**Eastern Sewershed Package IV Project  
Solicitation Number: CO-00149  
Job No.: 17-4527**

**ADDENDUM 3  
April 26, 2018**

**EA** EASTERN SEWERSHED PACKAGE IV INDEX AND QUANTITIES

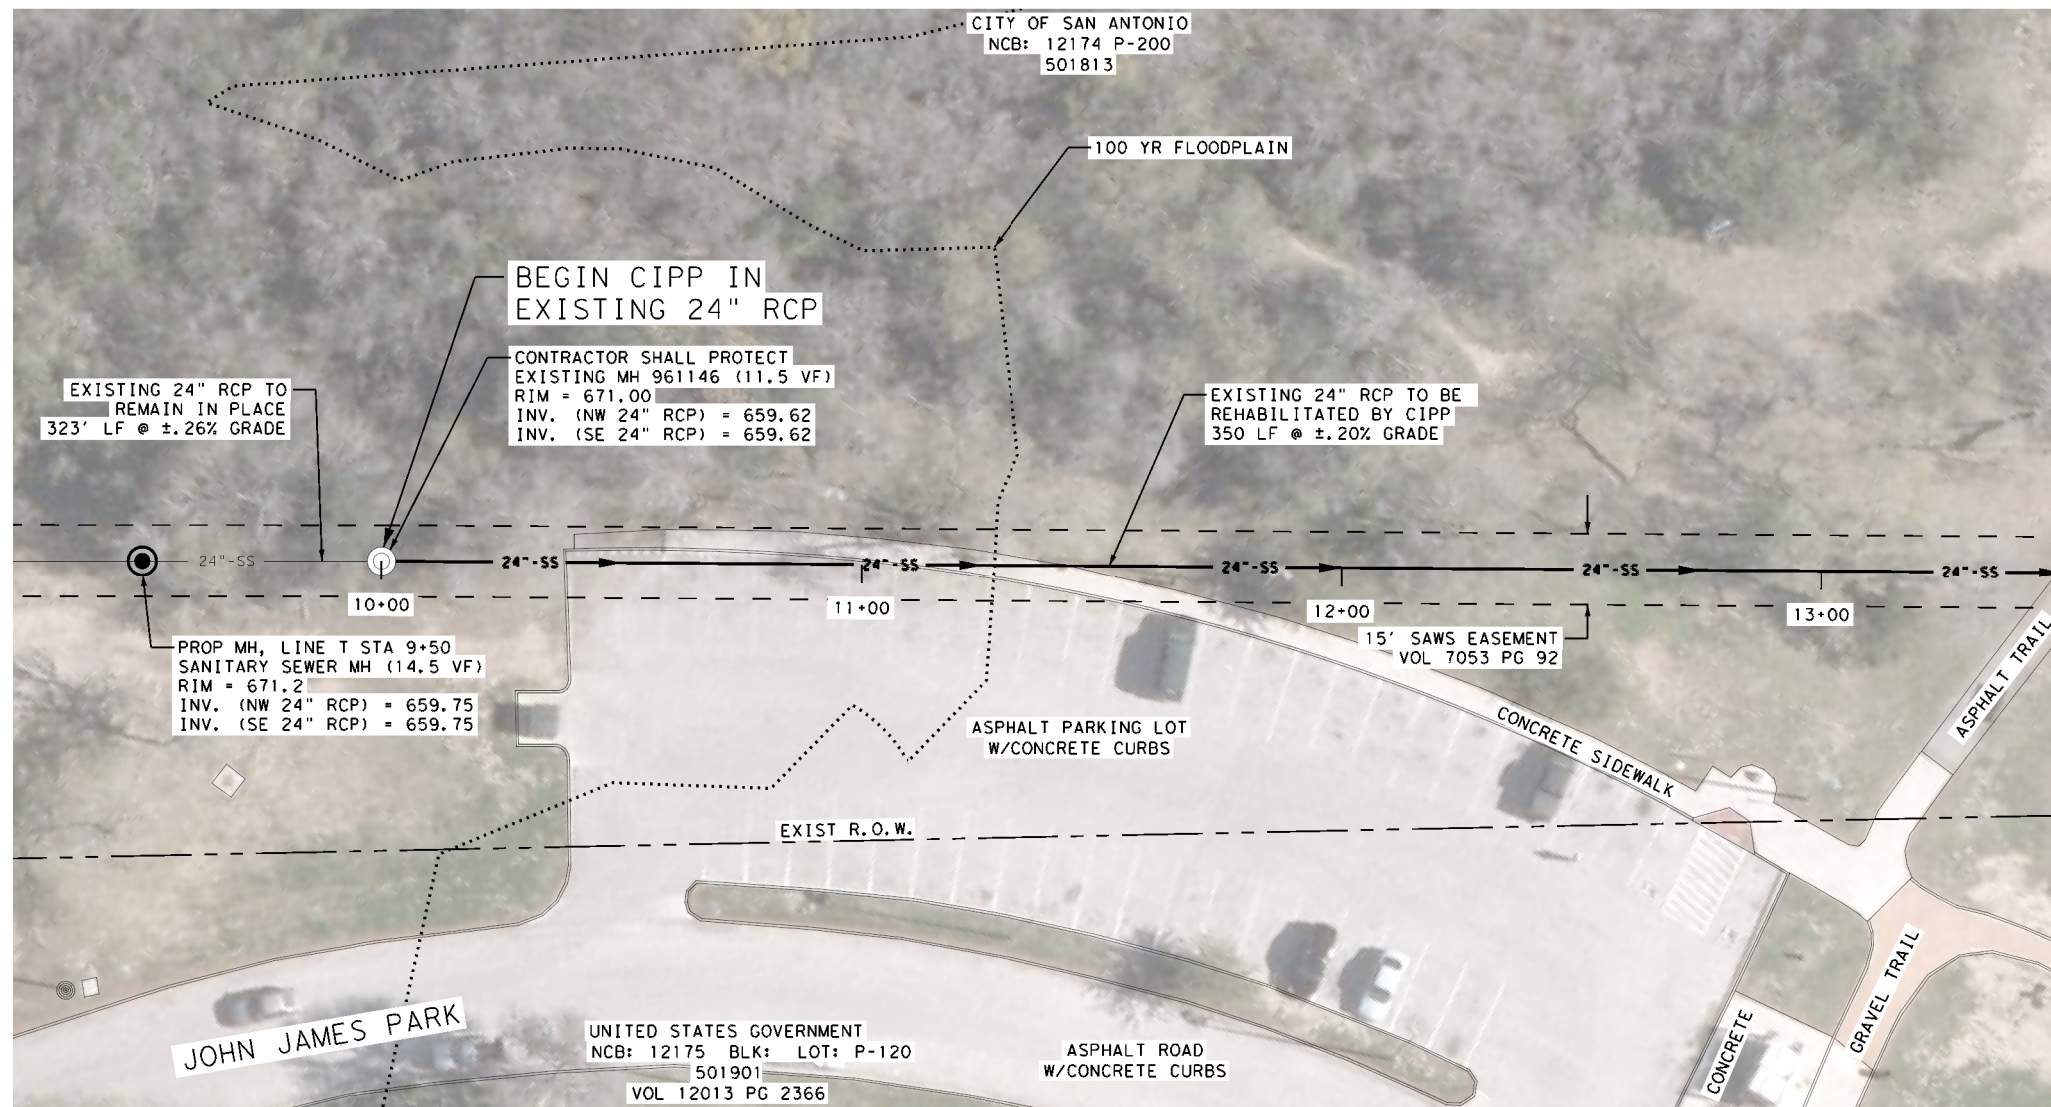
1. Plan Sheet 2 – Replace sheet dated 01/05/2018 with attached sheet 04/25/2018. Updates to plan sheet consist of revised quantities to manhole adjustments and manhole rehabilitation.
2. Plan sheet 31 – Replace sheet dated 01/05/2018 with attached sheet 04/25/2018. Updates to plan sheet consist of SAWS item 851.1 and 910.1 have been removed and quantities have been revised.

**SEWER PLAN - LINE T BEGIN TO STA. 13+50**

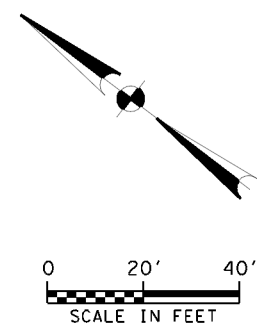
- 31. MH #961146 on sheet 31 on Line T is not shown with the symbol for rehabilitate manhole, and its noted description does not indicate it is required to be rehabilitated or adjusted, but from the table of estimated quantities on that drawing, it appears it is being included in the quantities for both manhole rehabilitation and adjustment. Will this manhole be required to be rehabilitated and adjusted?**  
*Manhole 961146 is not required to be rehabilitated or reconstructed. As part of this addendum, Plan Sheet 31 has been adjusted.*
